December 28, 2017

**Bear Swamp Project (FERC Project No. 2669)**  
**Response to Comments on the October 2017 Study Report Meeting Summary,**  
**Technical Study Reports, Requests for Modifications of Approved Studies, and**  
**Requests for New Studies**

**FIGURE 1**  
**SUMMARY OF BEAR SWAMP UNIT 1 AND UNIT 2 PUMPING OPERATIONS FROM**  
**APRIL 2005 THROUGH OCTOBER 2016**

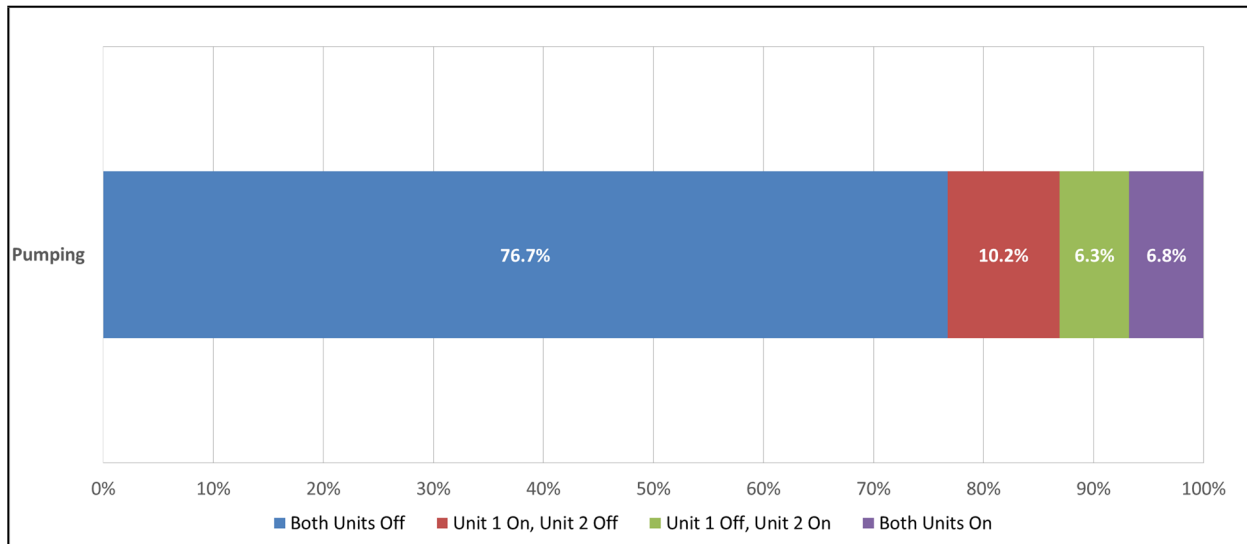
The CRC correctly noted that BSPC did not provide information in the PAD or in the Fish Entrainment Evaluation Study Report regarding how often both units at the Bear Swamp PSD are in operation. This information was not previously requested by stakeholders, nor was it a

requirement of the approved Fish Entrainment Evaluation study plan. Further, it is not clear how such information would meaningfully inform the results of the qualitative entrainment analysis presented in the Fish Entrainment Evaluation Study Report. The qualitative entrainment analysis is based on factors such as clear-bar spacing, seasonality, fish size and length, life-stage, and intake velocities. The timing of unit operation (i.e., which unit is on or off) is not necessary for the analysis. Nonetheless, BSPC is providing summary information on historic pumping operations in Figure 1 (generation is not relevant to entrainment potential at the Bear Swamp PSD).
